**From:** FREGONESE, Victor <vxf@nei.org>  
**Sent:** Monday, July 10, 2017 11:30 AM  
**To:** Morton, Wendell  
**Cc:** Waters, Michael; Rahn, David; 'Archambo, Neil G'; AUSTGEN, Kati; HANSON, Jerud; REMER, Jason; Drake, Jason; FREGONESE, Victor  
**Subject:** [External\_Sender] RE: Upcoming RIS Meeting - Advance Discussions and Proposed Agenda  
**Attachments:** NRC Draft Regulatory Issue Summary 2017-XX Supplement to RIS 2002-22 - NEI Feedback for Public Meeting [7-10-17].docx

**NRC DRAFT REGULATORY ISSUE SUMMARY 2017-XX  
SUPPLEMENT TO RIS 2002-22**

## **Draft** Qualitative Assessment Framework

Figure 1 - RIS Decision Tree Flowchart

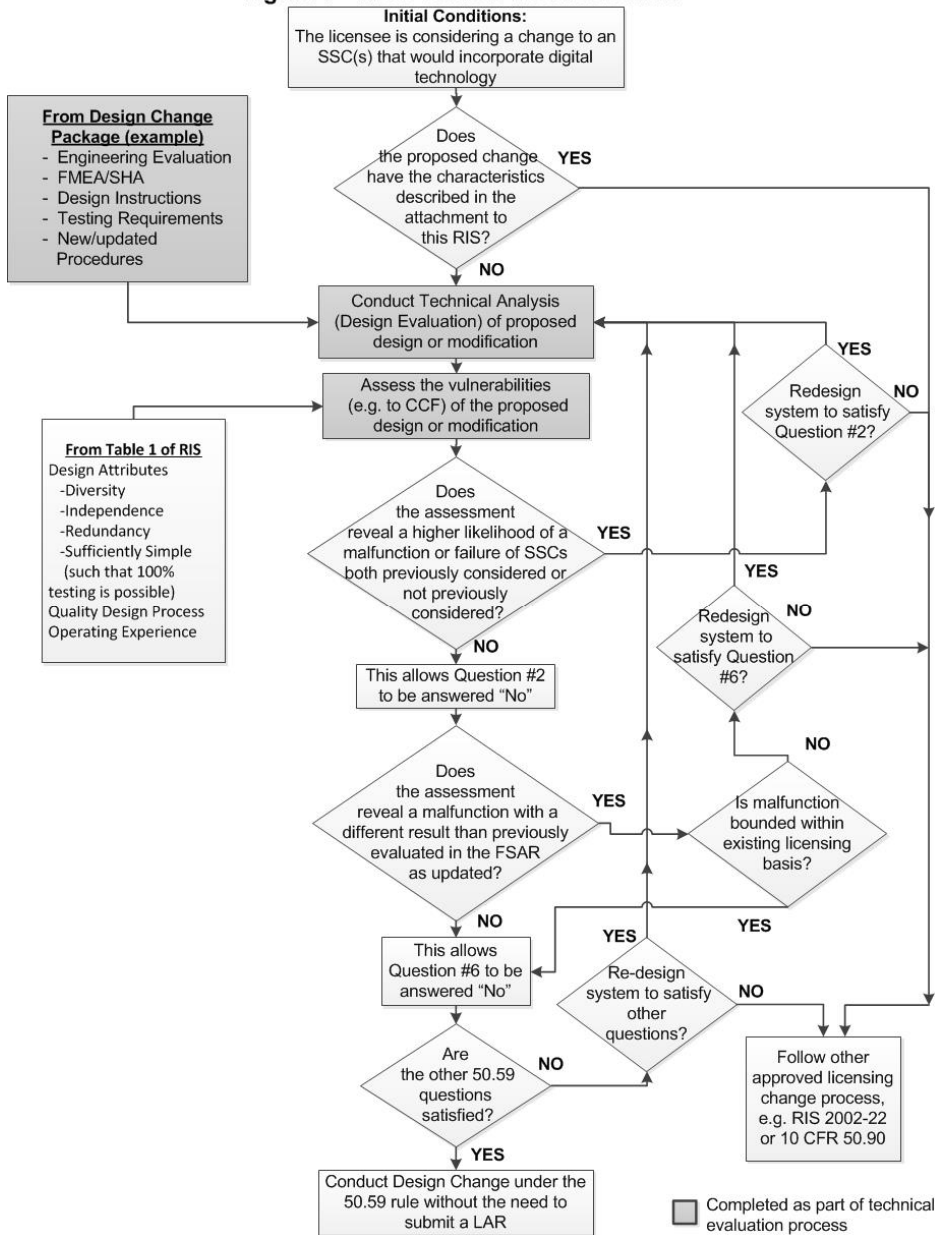
**Commented [NGA24]:** The first decision diamond asks "Does the proposed change have the characteristics described in the attachment to this RIS? Suggest being more specific by adding a specific section number of the RIS that details the characteristics. (RIS Section 3?)

Looks like the "Yes" and "No" decisions are reversed in this diamond - if the proposed change has the characteristics described in the RIS, shouldn't we then proceed to the Technical Evaluation?

Also noted that the flowchart only addresses 50.59 Evaluations Questions 2 and 6. Questions 1 and 5 do not appear to be addressed in the flowchart.
